H. R. LABOUNTY SAFETY AWARD PROGRAM NOMINATION FORM

Reason for Nomination: Recommending / designing enhancements to equipment

From: [Lee Patton](#)
To: [Terry Lofing](#)
Subject: Fwd: HR LaBounty Award Submission-Moulton Niguel - Marco Lazaro
Date: Wednesday, March 12, 2014 10:55:56 AM

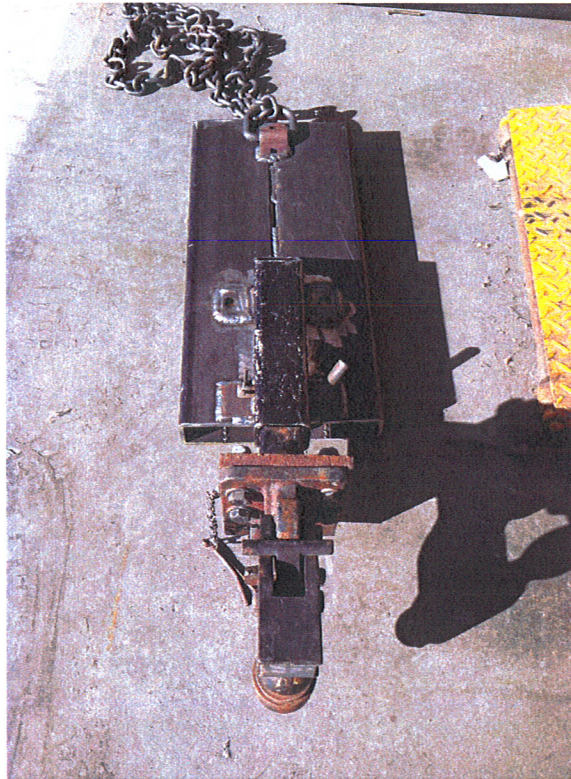
Currently, if District Staff has to move a trailer within our yard a nut and bolt is installed into one of the forks. There is the potential that the trailer can become separated from the forklift.

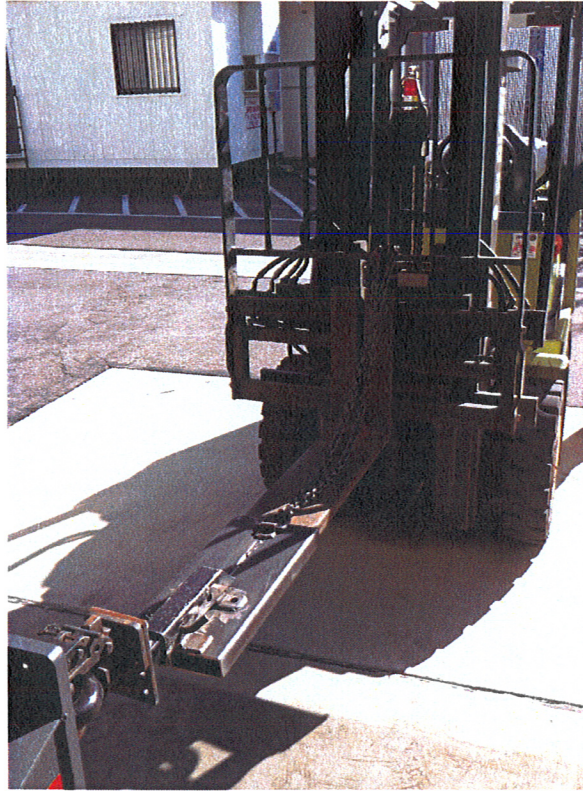
One last one. Fork lift is used to move large trailers in their yard. Trailers have multiple wheels, so hitch never touches the ground. Please include all in info sent to the guys. Lee

I have seen something like the first picture as an attachment to a forklift to pull a trailer around the yard. I like the modifications that have been done, but I am still concerned if the hydraulics were to fail on the forklift. What if someone were standing next to the hitch when this occurred? I am not sure using the forklift in this way is safe. What are your thoughts.

The updated configuration ensures that the trailer cannot become separated from the forklift.

I talked with Moulton Niguel. The attachment is only used when the trailer is being moved around. The trailer is not let attached to the forklift with the weight of trailer on the hitch.
